# SERVICE BULLETIN

Service Bulletin No.: D42L-27-01 Rev. 0

Title: **Modification to the  
Variable Elevator Stop System**

Figure 1 - Stick Limiter Schematic

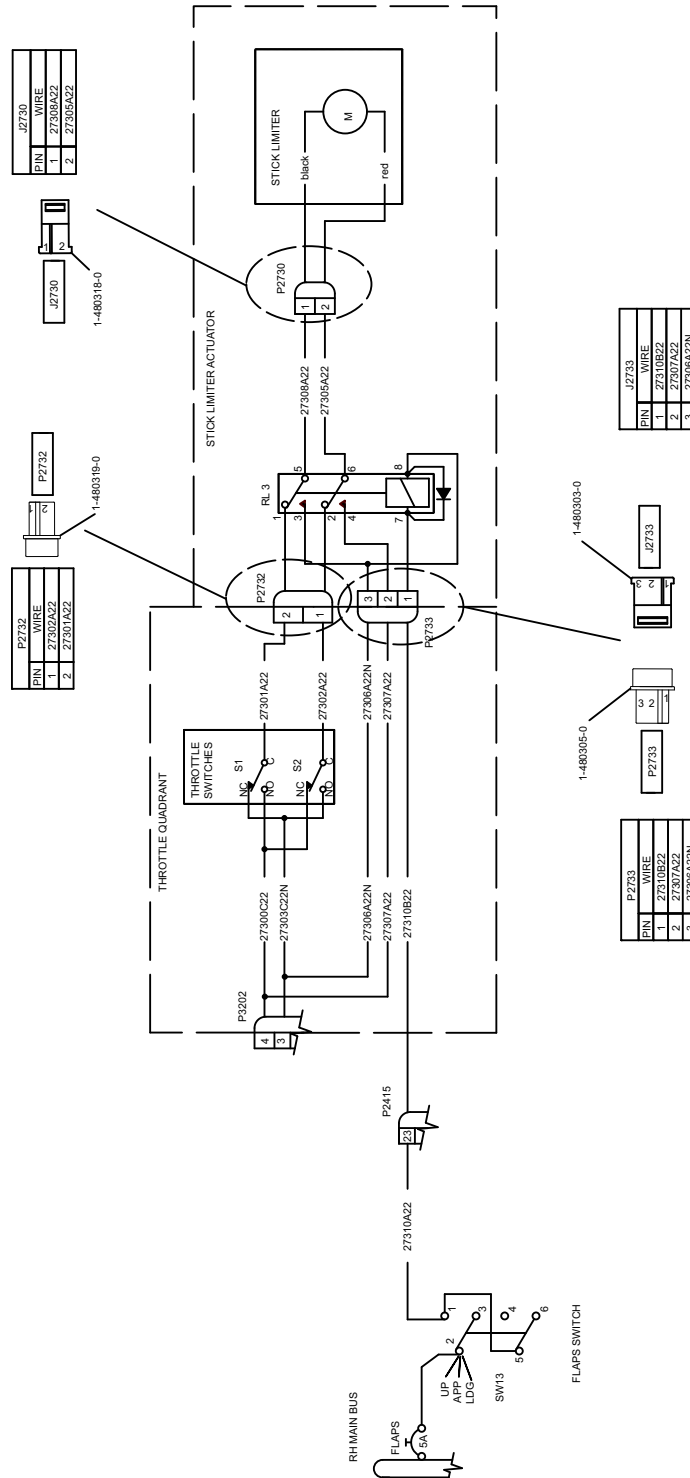
- 3. General:** Compliance with this Service Bulletin disables the variable elevator stop (stick limiter) when the Flaps are set to the APP (approach) or LDG (landing) position, offering increased elevator authority.

- 10.5 At the Flap switch, if wire 27310A22 is installed, move the ring terminal from terminal 3 to terminal 1. Refer to Figure 1.
- 10.6 If wire 27310A22 is not installed, use the 1 m 22 AWG wire (P/N M22759/16-22-9) provided.

- 
- 10.12 Remove the caps from the stowed wires for connectors P2732, J2730, J2733 and P2733. Terminate the wiring as shown in Figure 1 at switch RL 3 and apply the correct labels (P/N PS-250-2WT-2) provided.

- 10.13 Connect the mating connectors correctly.
  - 10.14 If wire 27310B22 is not installed in pin 1 of P2733, do as follows: Refer to Figure 1.
    - 10.14.1 Put the 1.7 m 22 AWG wire (P/N M22759/16-22-9) provided in expando (P/N 920-1-8-BKWH) provided. Trim the expando to the length of the wire.

- 10.14.4 Install pin P2733 (P/N 60618-1) provided on the other wire end and install it in connector P2733 at pin position 1.
  - 10.15 If wires 27306A22N and 27307A22 are not installed in either P3202 or P2733, do as follows: Refer to Figure 1.

- 10.15.3 Route wires in the 1 m expando (P/N 920-1-8-BKWH) provided to the stick limiter along existing harnesses.
    - 10.15.4 Connect wires in the P2733 as shown in Figure 1.
